IC Corporation

SAFETY RECALL 05507

August 2005

The diameter of the latch attachment bars may be so large as to make it difficult to use with future car seat attachments. In addition, some of the latch attachments may be located too far forward of the seat back.

Figure 1. Latch anchor brackets cut-off and belts installed

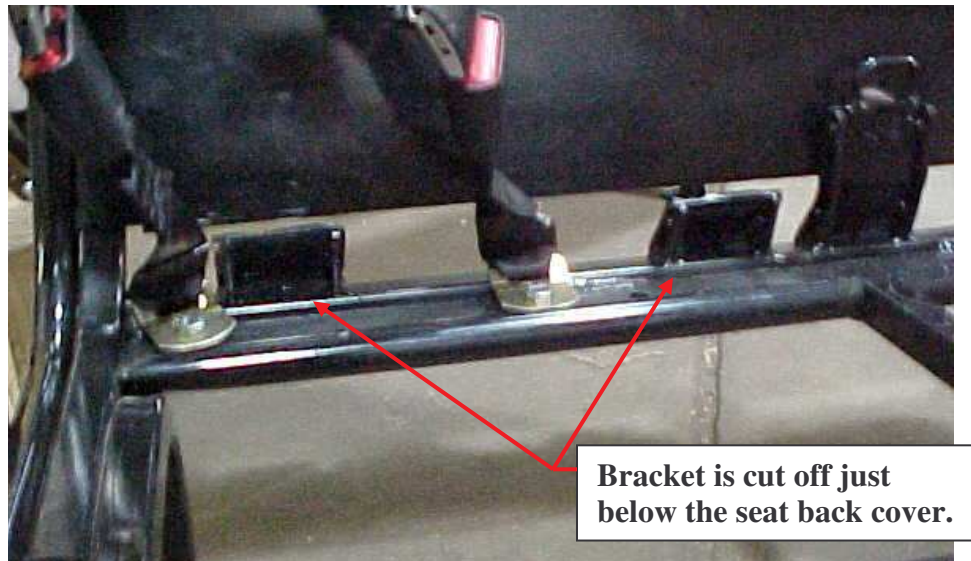
Remove latch attachments from seats and replace with a special belt system. This procedure does not require the removal of the seat assembly. Refer to Figure 1.

2. Cut the brackets off just below the seat back cover. Refer to Figure 1 below.
 - The bracket makes a bend in this area and has a minimum amount of material to cut through. It can be cut off closer to the seat frame if desired.

- 1. On seats without existing lap belts (Texas, North Carolina and Laidlaw only):**
 - a. After removal of the latch system, add one set of belts and hardware provided in **Kit # 8900150R91** (at each position that the latch system was removed) using the holes provided in the bar that are approximately eight inches apart.

- b. You may need to place a large diameter flat washer between the belt mounting bracket and the plate in the seat to get a flat mounting.
 - c. Torque the fasteners to **21-27 LbF-Ft (28.5–36.6 Nm)**.
